Access Compliance Report Public Rights-of-Way (Curb Ramps)

Main Street: BRIMHALL_DR Cross Street: FOSTER_RD Location: NW

ADA ID: RPRK211207124355 Ramp Type: Type 1 - Perpendicular Diagonal Initial Pass/Fail: Fail Overall Compliance: No Severity Score: 2

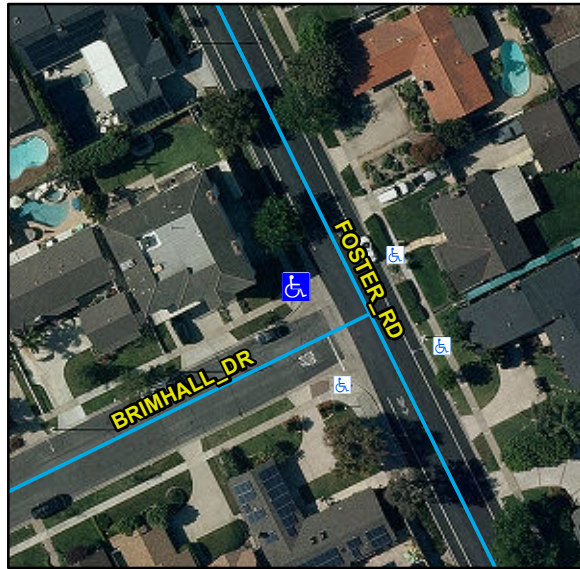
Compliance	Description	Data	Compliance	Description	Data
N/A	Ramp Length (in)	71	N/A	Flare Type LT	
Yes	Ramp Width (in)	48			N/A
Yes	Ramp Run Slope (%)	4.9	N/A	Flare Slope LT (%)	N/A
No	Ramp Cross Slope (%)	2.9	N/A	Flare Traversable LT	N/A
N/A	Landing Present	N/A	N/A	Flare Type RT	
N/A	Landing Length (in)	N/A			N/A
N/A	Landing Width (in)	N/A	N/A	Flare Slope RT (%)	N/A
N/A	Landing Run Slope (%)	N/A	N/A	Flare Traversable RT	N/A
N/A	Landing Cross Slope (%)	N/A	N/A	DWS Provided	N/A
N/A	Landing Movement Obstructed?	N/A	N/A	DWS Contrast	N/A
	Landing Movement Type	N/A	N/A	DWS Length (in)	N/A
N/A	Landing Shared	N/A	N/A	DWS Full Width	N/A
N/A	Clear Space	Yes	N/A	DWS Offset Left (in)	N/A
N/A	Clear Space To Crosswalk (in)	N/A	N/A	DWS Offset Right (in)	N/A
N/A	Marked Crosswalk 1	No	N/A	Marked Crosswalk 2	No
	Crossing 1 Direction	S		Crossing 2 Direction	E
	Marked Crosswalk 1 Width (in)	N/A		Marked Crosswalk 2 Width (in)	N/A

N/A	Ramp Inside Crosswalk 1	N/A	Yes	Ramp Inside Crosswalk 2	N/A
	Crossing 1 Slope (%)	8.6		Crossing 2 Slope (%)	6.1
	Crossing 1 Cross Slope (%)	2		Crossing 2 Cross Slope (%)	1.6
N/A	Gutter Ponding	N/A	N/A	Curb Slope	2.7
Yes	Gutter Lip Height (in)	0		Road Run Slope (%)	1.5
N/A	Gutter Run Slope (%)	N/A		Road Cross Slope (%)	1
N/A	Gutter Cross Slope (%)	N/A			
Yes	Overall Surface Condition: Acceptable		No	Perp Joint Present	No
	Cross Gutter Present?	Yes		Spandrel Present?	Yes
	Replace Cross Gutter?	No		Replace Spandrel?	No

Remove & Replace Curb Ramp With Two New Directional Ramps or Equivalent.
